PROJECT
RYLANDS BUILDING, MANCHESTER

TITLE
COMPARISON PLAN NINTH FLOOR

JOB No	DWG No	REV
1526	AL[05]4222	*

ISSUE FOR
PLANNING DOCUMENT

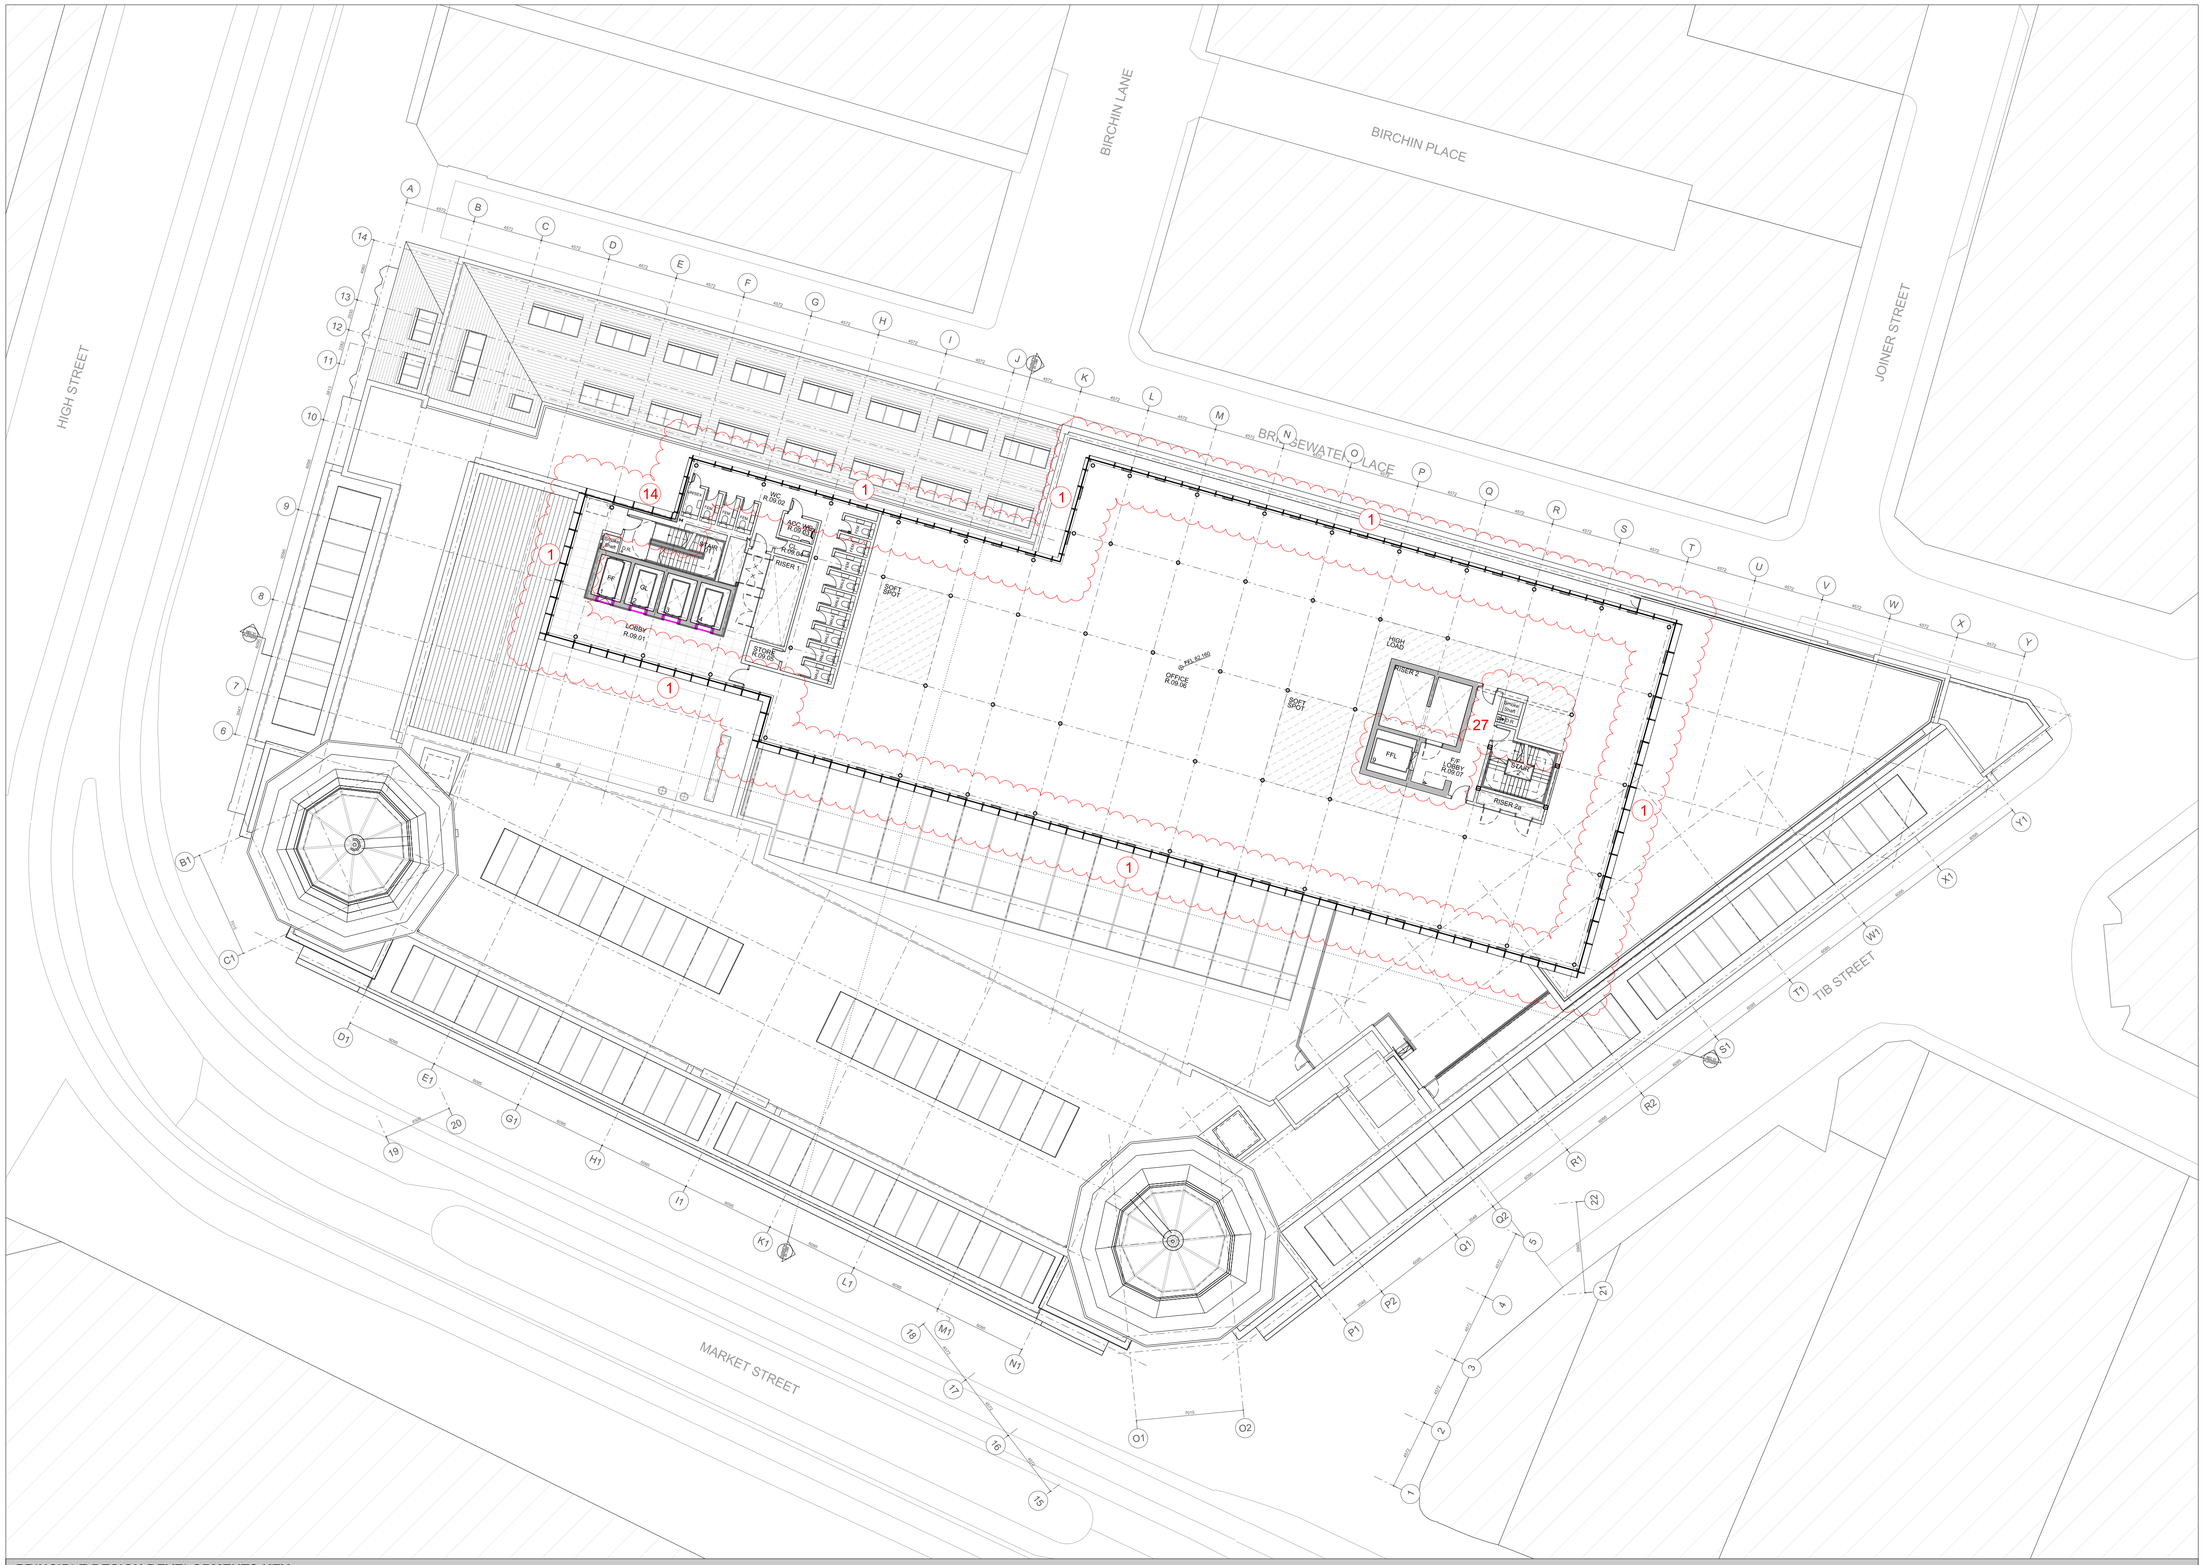
1. Double-mullions & Parallel Opening Vents omitted from extension elevations
2. Saw-tooth roof profiles reduced in number & length. Sawtooth structures to carry PV panels only, thermal envelope now at roof slab level.

3. Core 2 lift overrun height lowered within Roof Plant enclosure due to VRF MEP strategy.
4. Glazing sections to Atrium simplified.
5. Terrace 7A omitted. New back-painted glass screen to accommodate new VRF MEP servicing strategy at existing roof level. PPC vent louvres to lid, & to base of West elev, concealed behind main stone parapet.

6. New Market Hall Unit & revised Office Foyer at Ground Floor Level
7. Lower floors replanned (see notes on General Arrangement plan drawings).
8. Overall height remains unchanged from the consented scheme.

9. Roof-plant enclosure reduced in width & lengthened to GL. H to accom. VRF MEP strategy. PPC vent louvres to base of South & North elevs concealed by sawtooths.

10. Double-mullions omitted from Shop-front glazing
11. New fire exits required to Shopfronts for Market Hall use
12. New Market Hall entrance door arrangements

13. Updated Cycle-store entrance and exit arrangements
14. Back-painted glass in glazed facade system to match main facade system - Profiled metal cladding omitted.

15. Lift overrun wall widened to conceal adjacent plant.
16. Protected Lobby update.
17. Store area adjusted.
18. Lift 8 omitted. Void/Store/tbc
19. Drop shaft relocated.

20. Facilities Management & General Back of House areas updated to accommodate Market Hall.
21. Plant and bin store arrangement updated to accommodate Market Hall.

22. Lobby arrangement to increase locker provision within changing
23. Cycle lift & ramp omitted for new cycle-stair, reducing structural impact
24. Continuity of EXTG Floor area (hatched) subject to investigation - possibly ground bearing slab at high level

25. Updated lobby & stair entrance preserving more of existing building fabric.
26. Lobby arrangement to increase in area.
27. Core 2 Lift functions & service levels rationalised for efficiency

28. Ramp external to Stair 3 lobby
29. Equipment Room provided.
30. Rooflights rationalised into singular rooflight
31. Cleaning facilities provision updated.

32. WC added.
33. Extg balconies refurbed for reuse.
34. Winter Garden omitted.
35. External fabric amendment to accommodate existing structure.
36. Existing doorway retained, new door fitted to match new adjacent.

37. Security bollards to Bridgewater Place entrance.
38. Bird & batbox proposed locations included.
39. Partition line moved to increase commercial space.

40. Green roof to flat roof of L7 link.
41. Ducting terminations in aesthetically coordinated metal sheathing.
42. Renewables omitted @ L7 roof.
43. Horizontal plant-screen fins omitted.

44. Overrun of Lift 10 removed.
